A12 Chelmsford to A120 widening scheme

DEVELOPMENT CONSENT ORDER CHANGE APPLICATION CONSULTATION

Junction 19 Slip Road Technical Note

April 2023

Plate 1.1 Junction 19 – Redesign of north bound on slip road

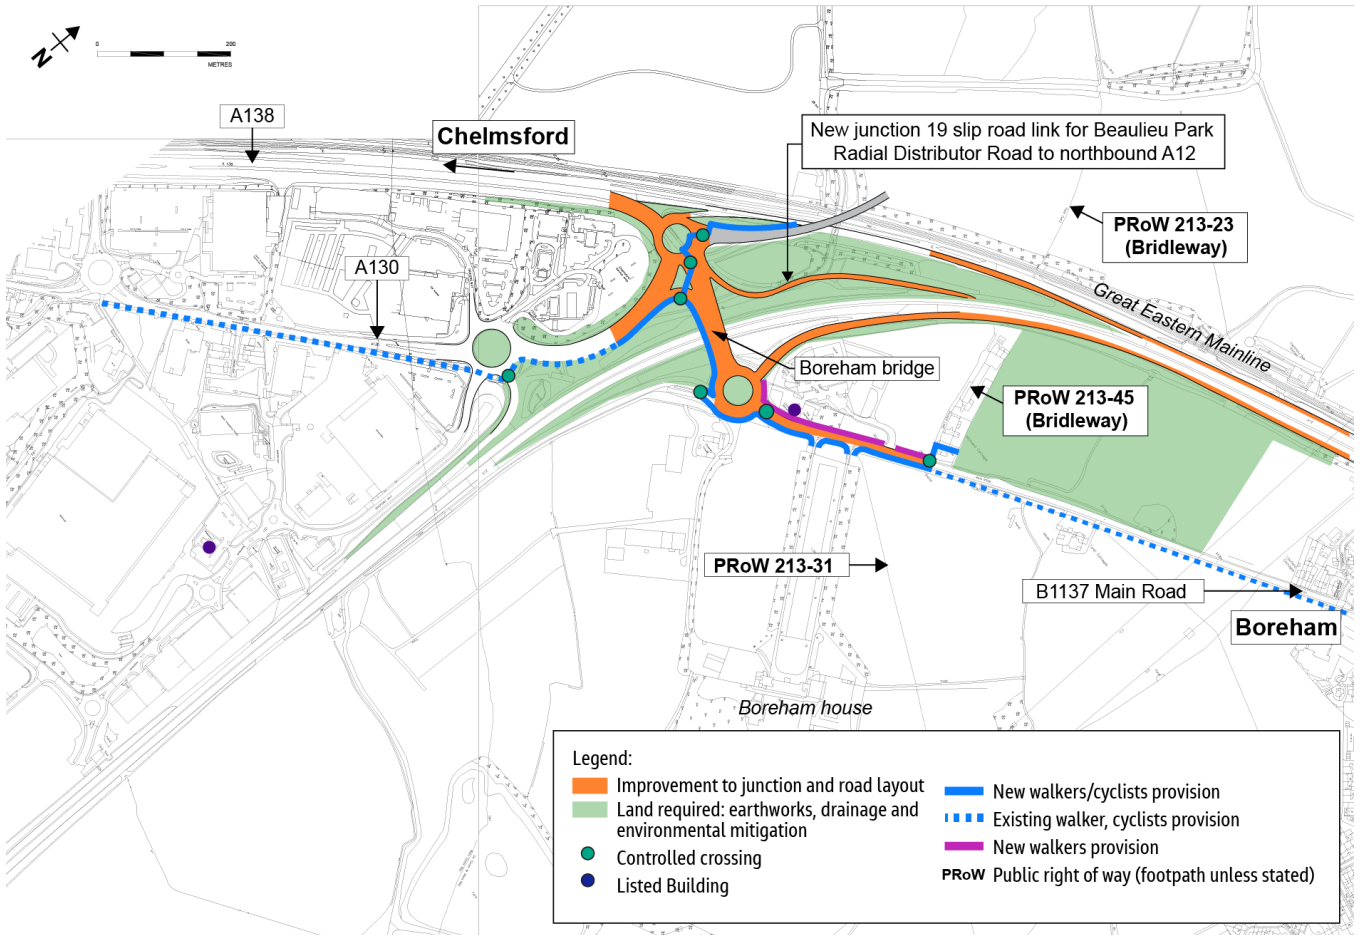
- 1.1.8 In the DCO application, traffic wanting to travel between the Beaulieu Park Radial Distributor Road and the northbound A12 would use a segregated left-turn lane, which connected to the existing Junction 19 Northbound On-slip Road. This merge was proposed to use an offside merge, which would require traffic to join the offside lane 2 of the Junction 19 Northbound On-slip Road.
- 1.1.9 It is proposed that this arrangement could be improved by connecting the link from the Beaulieu Park Radial Distributor Road directly to the A12 northbound carriageway. This proposed merge will be more conventional, in that the merging slip road would join the nearside lane 1 of the A12.
- 1.1.10 The proposed new merge is sufficiently far from the existing junction merge and overall improves safety for road users due to the more conventional layout.

There are no changes to the arrangement for walkers, cyclists or horse riders as a result of this refinement. There are consequential changes to the utility diversions in this area including the removal of the diversion of a buried water main that is no longer required.

1.1.11 As part of the detailed design process which is happening in parallel with the DCO examination, the configuration of the northbound slip road at junction 19 has been refined to allow traffic to merge directly with the A12. This new design improves the safety for road users when joining the A12 northbound at junction 19.
